Takes of Marine Mammals Incidental to Specified Activities; Taking Marine Mammals Incidental to an Exploration Drilling Program near Camden Bay, Beaufort Sea, Alaska

ACTION: Notice; issuance of an incidental harassment authorization.

SUMMARY: In accordance with the Marine Mammal Protection Act (MMPA) regulations, notification is hereby given that NMFS has issued an Incidental Harassment Authorization (IHA) to Shell Offshore Inc. (Shell) to take marine mammals, by harassment, incidental to offshore exploration drilling on Outer Continental Shelf (OCS) leases in the Beaufort Sea, Alaska.

Figure 1. Band levels for the Kulluk during drilling.

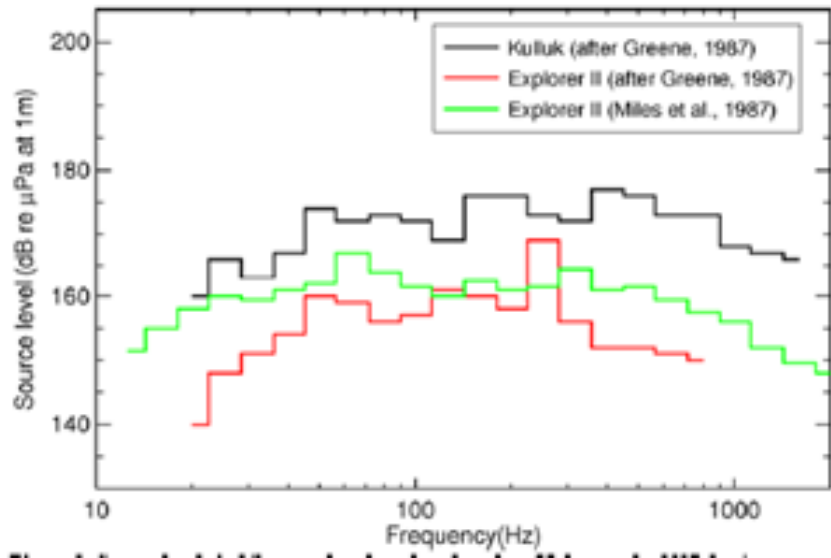
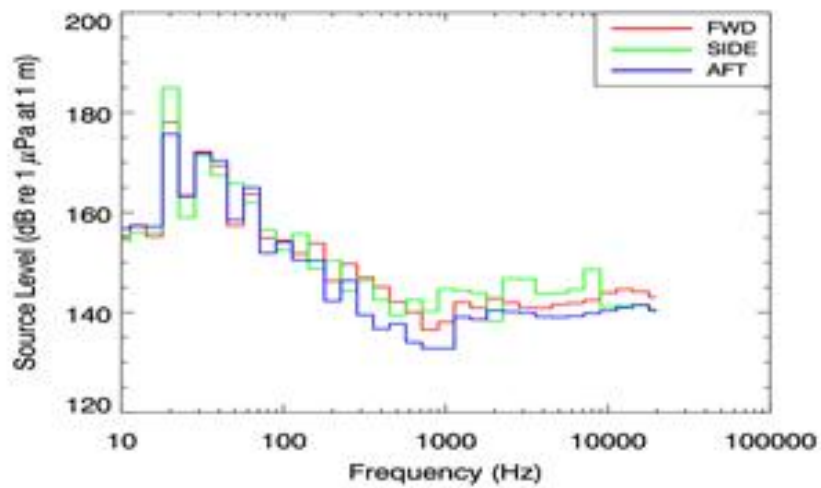
Comment 4: The MMC and AWL question the source levels and harassment zones for the two drillships. If the source levels for the Kulluk and Discoverer are nearly identical, then why is there a four-fold difference in the size of the corrected harassment zones for the two drilling vessels?

Response: Differences in sound propagation from the two rigs are real and are caused by differences in the design of the two vessels. While the broadband source levels for the Discoverer and Kulluk may be similar, their spectral properties differ considerably. Acoustic

modeling considers the source levels in 1/3-octave frequency bands. Figures 1 and 2 show the band levels for both drillships during drilling. Of key importance are the significantly lower levels of the Discoverer in the 50 to 500 Hz bands that propagate well in the relatively shallow waters of these drilling operations. While the Discoverer apparently has higher band levels below 50 Hz, this energy is more rapidly attenuated than higher frequency sound energy. This characteristic of sound propagation in shallow waters leads to predominantly mid-frequency sounds (50-500 Hz) dominating the acoustic field at distance from the drillships. A further consideration is that the Kulluk source levels are known to include contributions from support vessels, and much of the mid-high frequency band energy in its source levels may not originate entirely from the drillship itself, as acknowledged by Greene (1987). The Discoverer source level measurements by Austin and Warner (2010) were made at closer distances and do not include significant contributions from other vessels. The Kulluk's modeled sound footprint may be an overestimate as a result, but we cannot quantify by how much since the relative contribution of vessel noise to its source level measurements is unknown. The source level for the Discoverer was measured, though not in the Beaufort Sea, and those measurements were used to model propagation in the Beaufort Sea environment. Regardless of which drill rig is used by Shell in the Beaufort Sea in 2012, the IHA requires Shell to conduct sound source verification (SSV) and characterization tests on all equipment used.

Figure 3. Sound speed profile used in drill rig modeling.

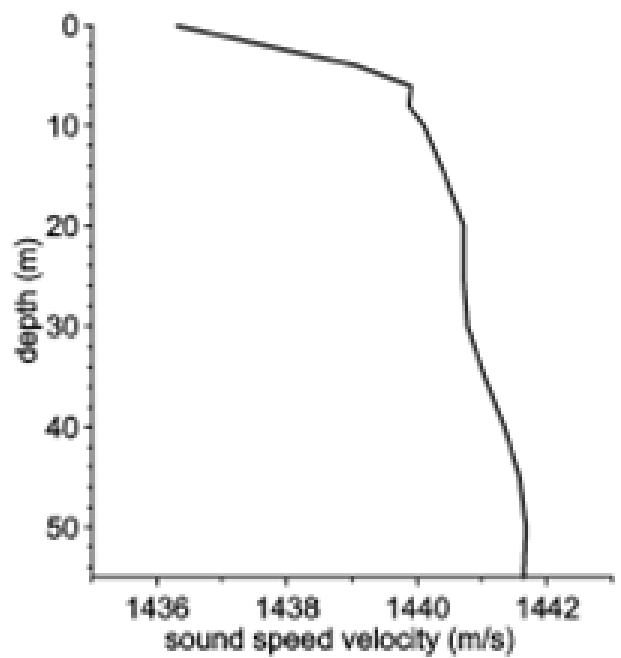
Comment 26: Dr. Bain states that the correction factor of 1.5 applied to the distance to the 120 dB contour is inadequate to conservatively account for the variability.

Response: The concern raised here is that the sound speed profile used for acoustic modeling of drill rig noise may not account for changes to the salinity and temperature profile that could influence and create variability in sound propagation, and the resulting variability might lead to conditions in which model estimates would not be conservative. While significant structure can form in the sound speed profile, the profile used for this modeling study was taken from the GDEM database for the corresponding locations and timing (month of September was used). The specific profile chosen (see Figure 3) has increasing sound speed with depth over the full water column. This profile leads to upward acoustic refraction that causes propagating
